Appendix D Complete set of replies received from TII

Doc. No. P0027301-1-H3 Rev. 0 - September 2022

For the RFIs from #1 to #4 and #6, the following documents have been received.

Musgrave Site alternative station location

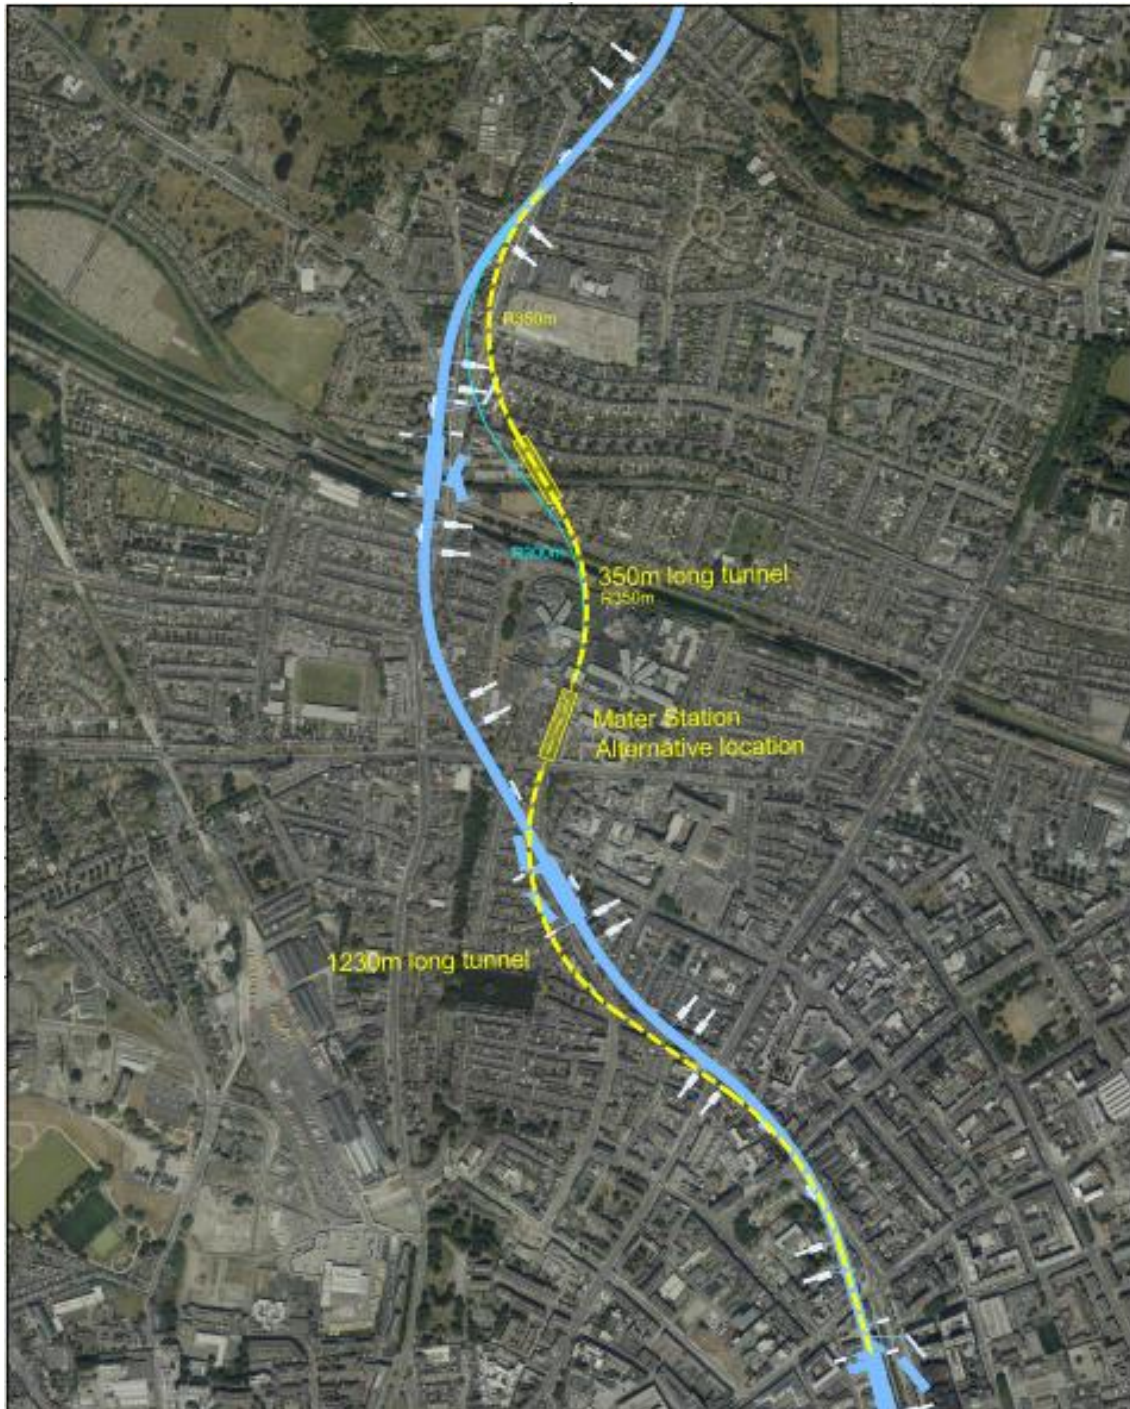
District 7 Community Alliance suggested an alternative of the alignment in their area, which seem to be appropriate for a response.

The proposed alignment is much straighter on the eastern side of Botanic Road, passing straight down from the Griffith Park stop, under the Smurfit site and interchanging with IE under the present tennis courts, again a good construction site compared with the one proposed by TII. The line could then travel straight under the Canal, the corner of Mountjoy and have a station at the 'Musgraves' site, avoiding the difficulties associated with passing under so much poorly founded housing with a very curved alignment and giving a far better site for constructing the station behind Mater, rather than in Four Masters Park.

TII have previously assessed a station location at the Musgrave site in 2020 (below) in lieu of the currently proposed Mater Station in its current location.

The findings from the desktop study are as follows:

- a) Proposed Musgrave Station would be constrained by limiting horizontal curve alignment of 350m to the north, which would allow to place "East Glasnevin Station" on straight section of the alignment. Position of the proposed station would be east of tennis courts and would significantly impact on the residential area north of GSWR.

- b) Placement of Irish Rail platforms would be impact on surrounding area (see below).
- c) The tunnel section between the proposed station beneath the Musgrave site and the Glasnevin "East" Station would be only 350m which would impact on the efficiency of MetroLink operational pattern (90 seconds headway) and passenger demand.
- d) Omitting Mater Station from the scheme would result with 1230m long tunnel between the station at the Musgrave site and O'Connell Station. Consequently, an intervention shaft would be required between stations to satisfy safety requirements of maximum 1,000m distance between emergency exits.
